RE: RESPONSES TO MPUC INFORMATION REQUEST NOS. 15-20 & 21 PUBLIC
ACQUISITION OF THE MANKATO ENERGY CENTER (MEC)
DOCKET NO. IP6949, E002/PA-18-702

Xcel Energy Information Request No. 15
Docket No.: E002/PA-18-702
Response To: MN Public Utilities Commission
Requestor: Sean Staples
Date Received: June 17, 2019

Attachment A – 7C

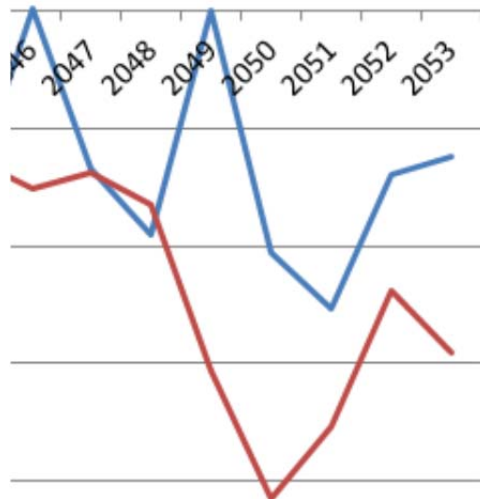
Please refer to Attachment A – 7C and Attachment B – 7C. The relevant excerpts from the figures are shown below.

20.a. Regarding Attachment A – 7C, what explains the spike in PVRR (red line) savings in the 2048-2050 timeframe?

20.b. Why does the spike not occur in the PVSC (blue line)?

20.c. A similar spike in PVRR savings occurs in Attachment B – 7C, but in 2033. Why does this spike occur earlier in the study period than in Attachment A – 7C?

- a. The expansion plans for the PPA and ownership scenarios have the same amount of solar in 2048, but the ownership scenario has 1,000MW less solar in 2049-2057.
 - b. See response to part (a). The reduced solar in these years for the ownership case results in higher CO2 emissions, which incur regulatory costs under PVSC assumptions.
 - c. The spike in Attachment B has no relationship to Attachment A. In the modeling for Attachment B, the ownership case is avoiding a CC unit in 2033 that is in the PPA case.
-
